FIELD REPORT – LYNNWOOD RECREATION CENTER – FIELD REPORT
REPORT #10

Job No. 10-100622B1

Date: October 14th, 2013
Page 1 of 11

Location(s) of Work: Southeast & Southwest of the Natatorium Roof

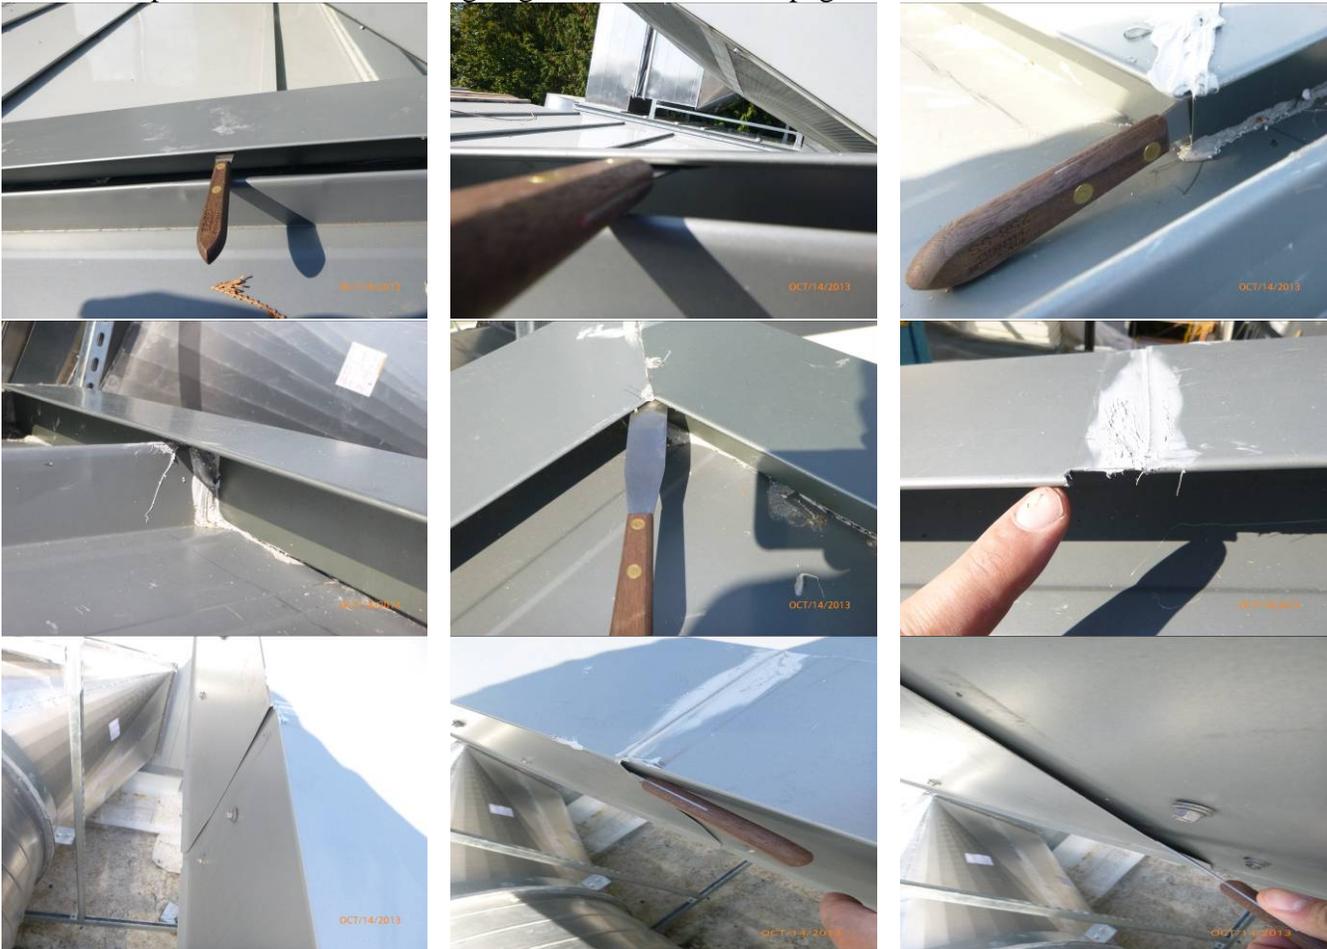
10.4 At the north side of the Natatorium Roof, it is recommended that steel draw-bands are installed at the through roof penetrations. Sealant appears to be installed and per conversation with Rich Kern, (Foreman, QCR) this is a work in progress. The copper through roof penetrations are temped over with duct tape and polyethylene sheeting as a means to prevent water intrusion into the building and existing roof. Item is noted as an observation.

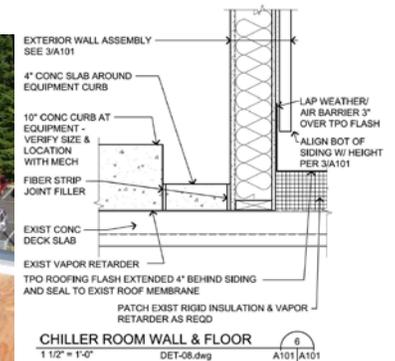
10.6 As an existing condition, at the roof areas to the southeast of the Natatorium Roof, sealant does not appear to be applied at the tops of through roof penetration flashings.

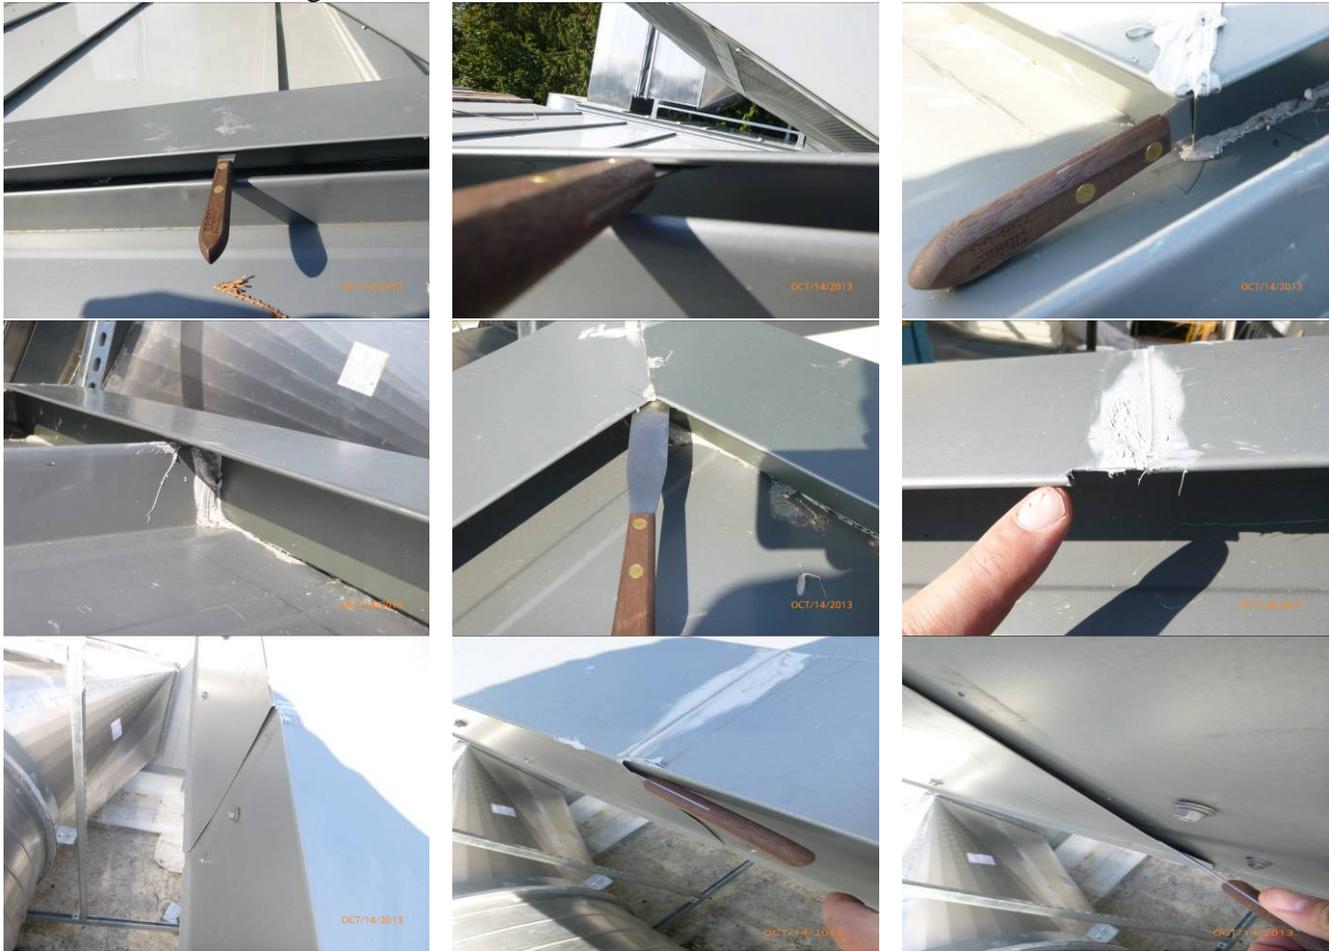
8.7 The absence of a night seal at the chiller room roof allowed water to migrate into the existing roof to the east. The roof to the east was previously observed as wet along with the existing roof that was removed to the west.

Update FR#09 – 10/03/2013: Item is unresolved

Update FR#10 – 10/14/2013: Item is unresolved.

Roof Progress Plan / Locator Map:

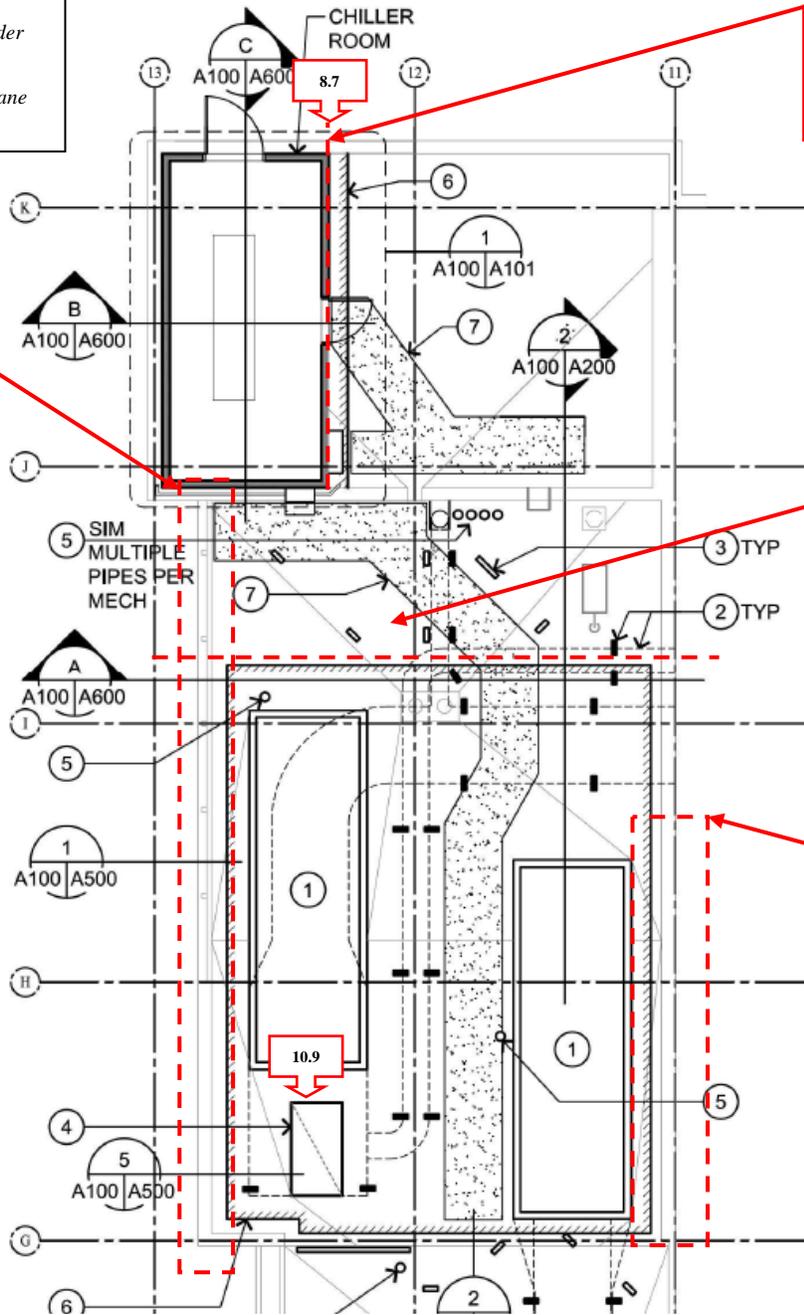
Item 8.4: Infill holes in top plates at screen wall structure.

Problems Item 8.8 – sheet metal re-installation at the upper steep slope roof to accommodate new HVAC.
